**CITY OF SEATTLE
ANALYSIS AND DECISION OF THE DIRECTOR OF
THE SEATTLE DEPARTMENT OF CONSTRUCTION AND INSPECTIONS**

Application Number: 3020482
Applicant Name: Chip Kouba for Ecco Design Inc.
Address of Proposal: 5611 17th Ave NW

Land Use Application to allow a 6-story congregate residence with 74 rooms. No parking is proposed. Existing structures to be demolished.

CURRENT AND SURROUNDING DEVELOPMENT; NEIGHBORHOOD CHARACTER

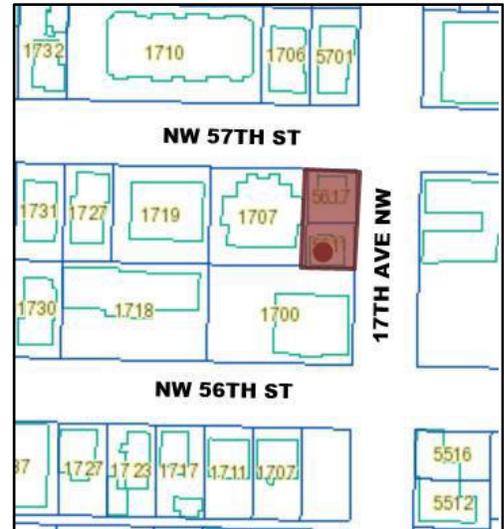
The surrounding area is characterized by a mix of midrise and lowrise multifamily buildings. The site is relatively flat with approximately four feet of grade. The site slope is slight from northeast to southwest.
